**EL PASO WATER UTILITIES  
PUBLIC SERVICE BOARD**

**ADDENDUM 2  
FOR**

**HASKELL R. STREET WASTEWATER TREATMENT PLANT FATS, OIL AND  
GREASE RECEIVING STATION IMPROVEMENTS**

**BID NUMBER 93-22**

**E-03**

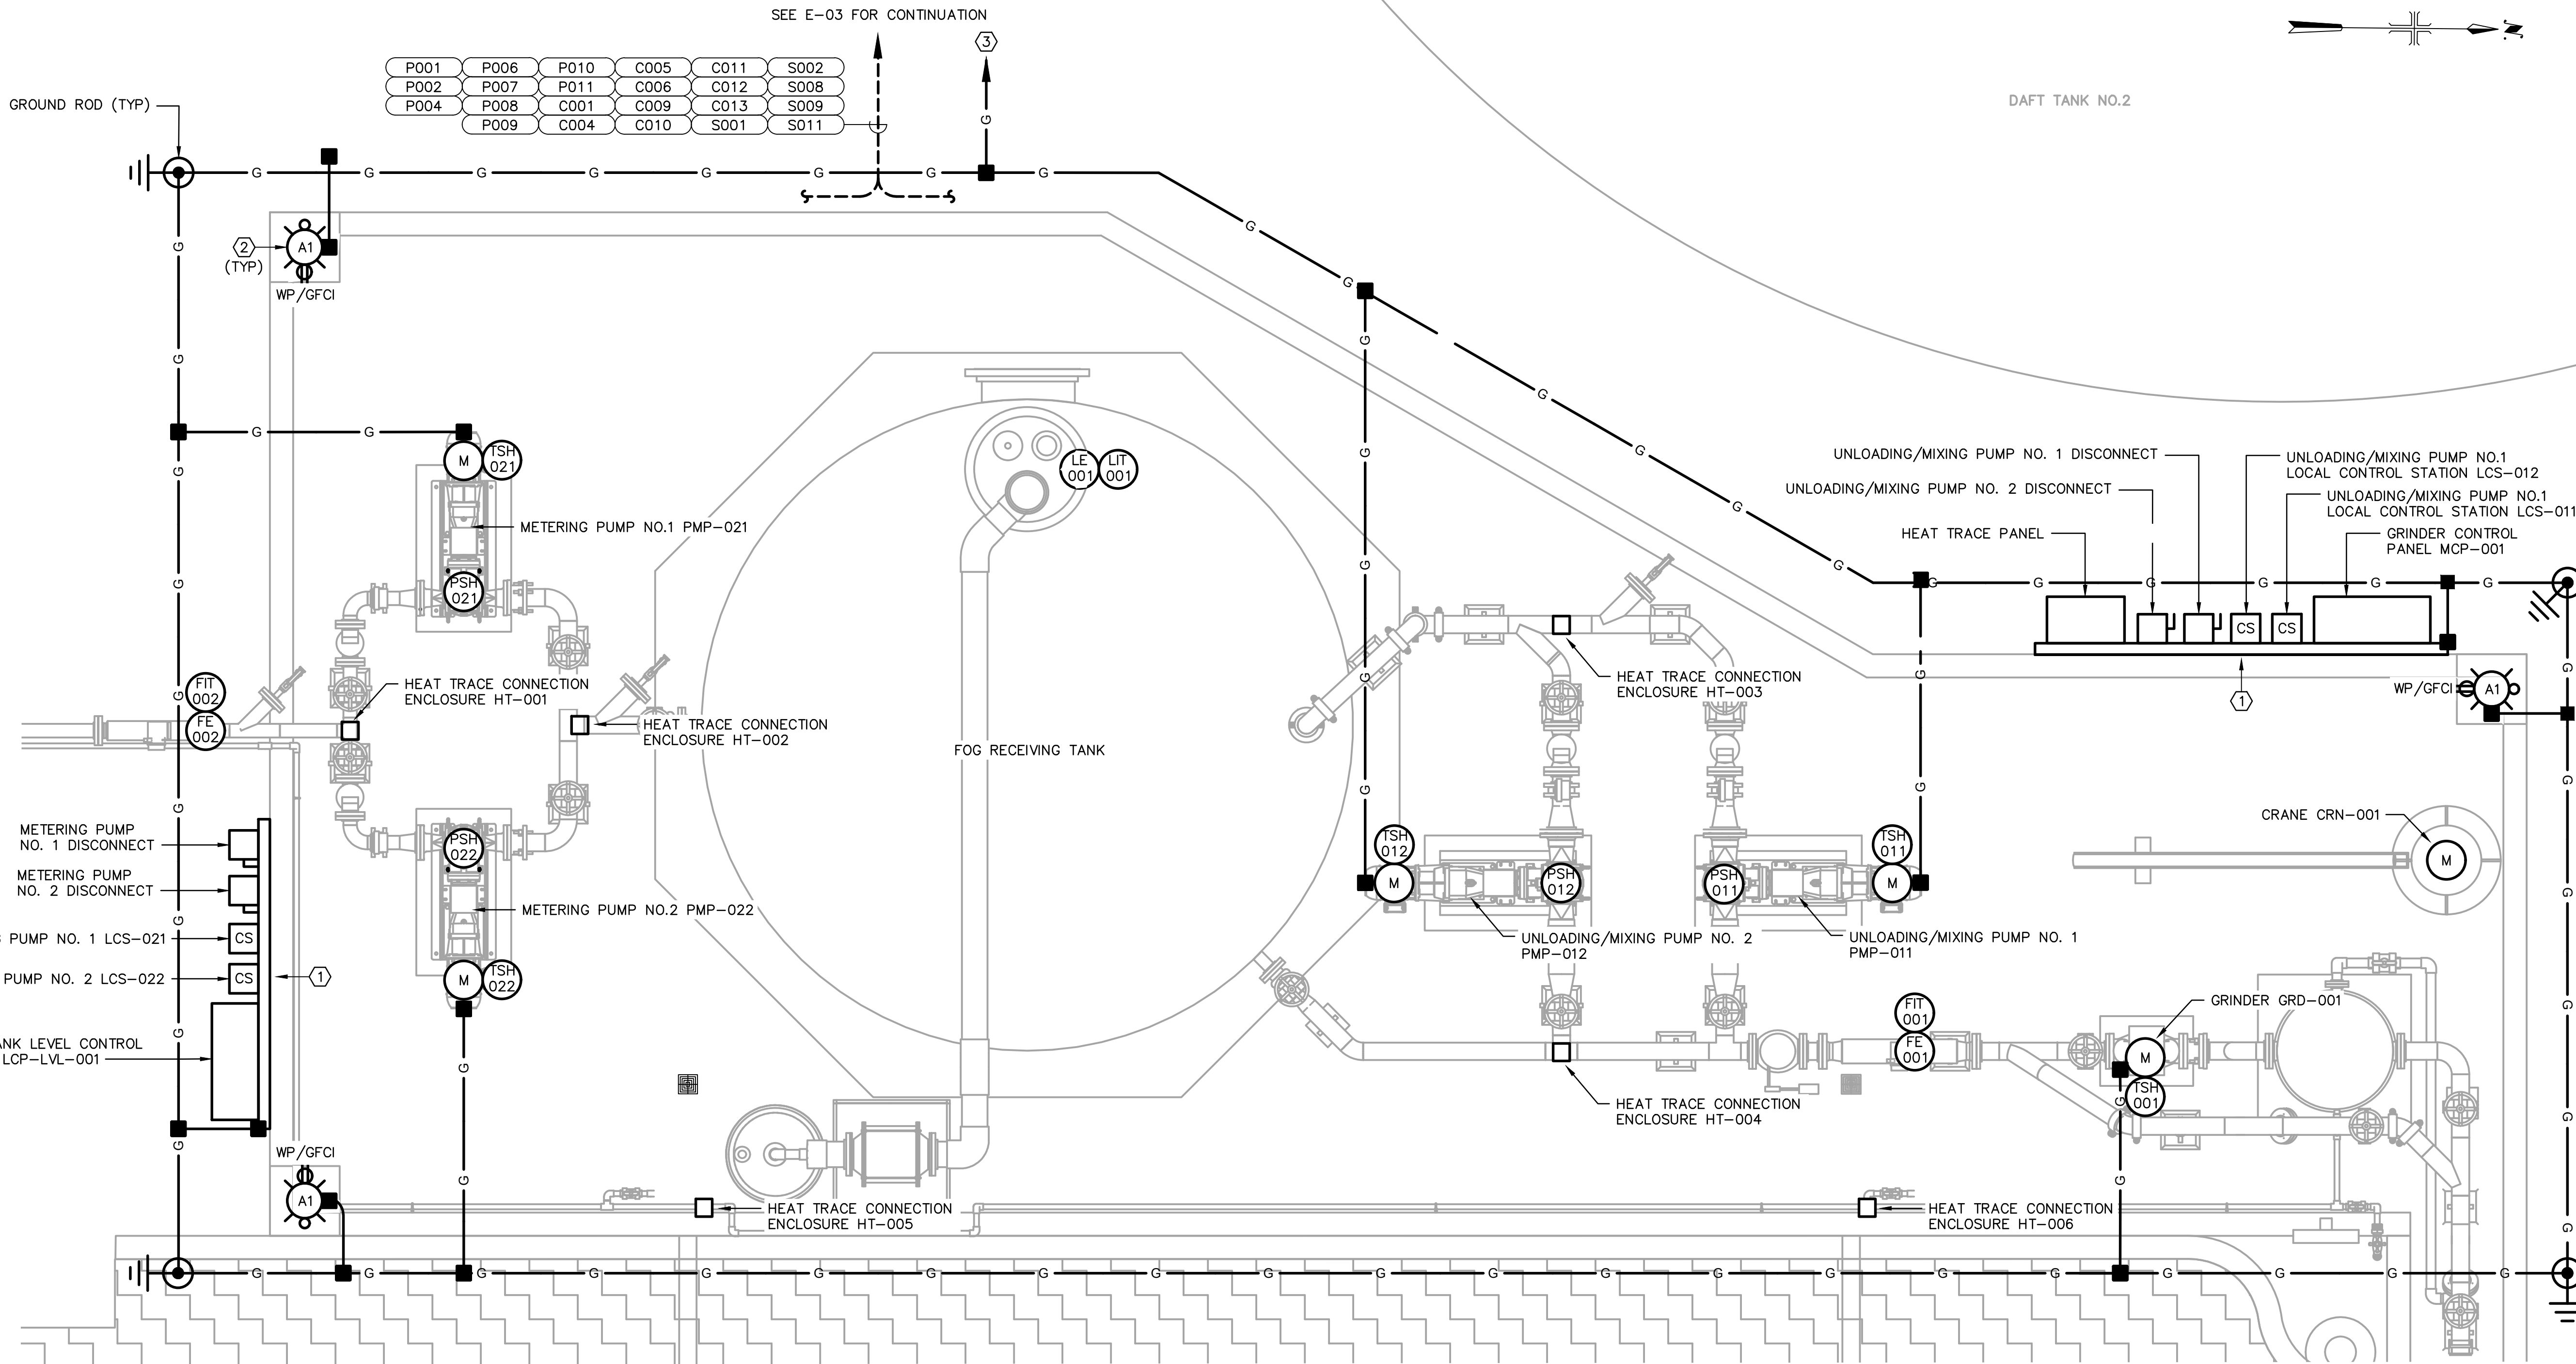
**QUESTION 8:** It appears the scale is off on sheets 27, 28 and 30 please check?

**ANSWER 8:** Sheets E-02, E-03 and E-05 have been revised to correct the scale. Revised sheets are attached.
